APPENDIX E

Updated Assessment Addressing Part of Director Generals Environmental Assessment Requirements

PROPOSED 7 LOT SUBDIVISION & BOUNDARY ADJUSTMENT

“PICNIC POINT” IVOR JONES DRIVE, WONBOYN LAKE

Figure 1; Bega Valley Shire Council Property Map

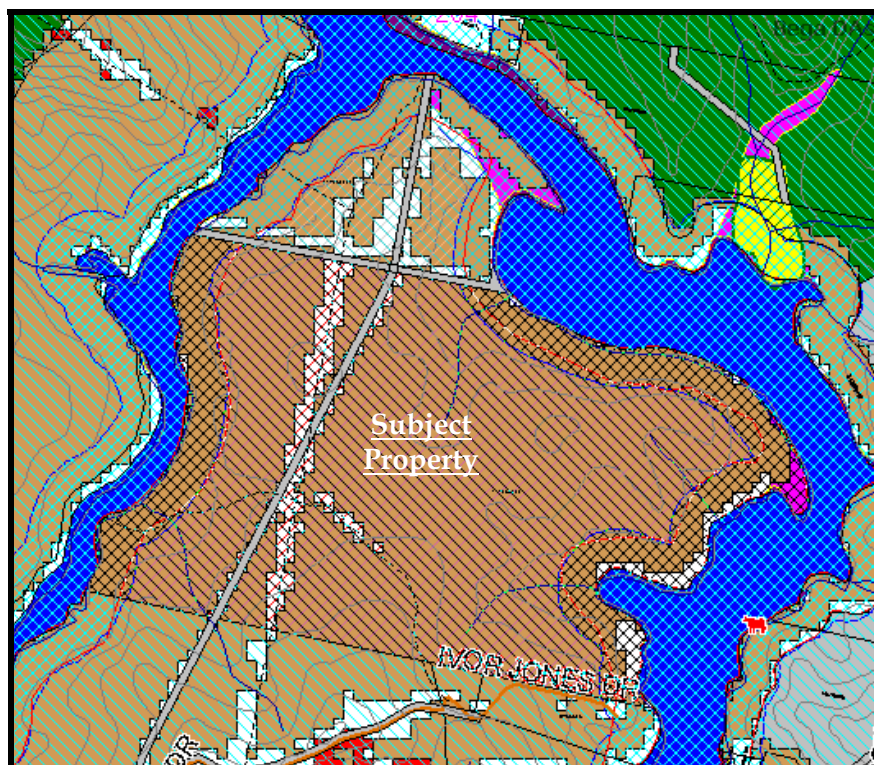
Department of Planning Key Issues	Response	Section of this report
<p>Item 2 c) Flooding: This assessment states that <i>"flooding of the main road has occurred at a frequency of approximately once annually"</i>. Clarification is required on which road is being referred to and the source of this information.</p>	<p>This paragraph of the report has now been reviewed, and confirmation included that the road being referred to is the Wonboyn Road. Additional information based on recent rainfall events has also been included, as well as a statement regarding the source of the information, as local knowledge only.</p>	<p>Item 7, Page 13</p>
<p>Item 2 d) Water Supply: There has been insufficient information provided to demonstrate that each proposed lot will have access to a sustainable water supply, such as through the use of rainwater tanks or harvesting from stormwater runoff from roof areas.</p> <p><i>Water supply was also listed as a separate matter under Item 7, which has been specifically addressed in the Updated Bushfire Assessment (Attachment 4).</i></p>	<p>This firm addressed water supply from a bushfire perspective, and as part of a review and update of the Bushfire Risk Assessment, the minimum water supply to be dedicated for fire fighting purposes has been increased to 20,000L. Required water supply dedicated for fire fighting purposes has been increased to 20,000L per lot, in line with revised RFS guidelines.</p> <p>The remaining issues raised in regards to water supply have been addressed by SEEC Morse McVey.</p>	<p>Item 9.2, Page 18</p>

Council have provided us with their map of the subject property (below), clearly showing no flood prone land, and stating:

"There are no features selected with information in the table 'Flood Area'."

This indicates that Council has not recorded the subject property to be subject to flooding.

However, the surrounding properties, as indicated in the diagram below, are shown to be affected, with the light blue cross-hatching shown around the foreshore area. This area also appears consistent with the 7(b) Zone boundary, and as such, is not considered to be reliable flooding records (based on actual flooding information).

Enquiries with Bega Valley Shire Council have confirmed that they hold no flooding data of the Wonboyn River, again, reflected in the above map, (Figure 1).
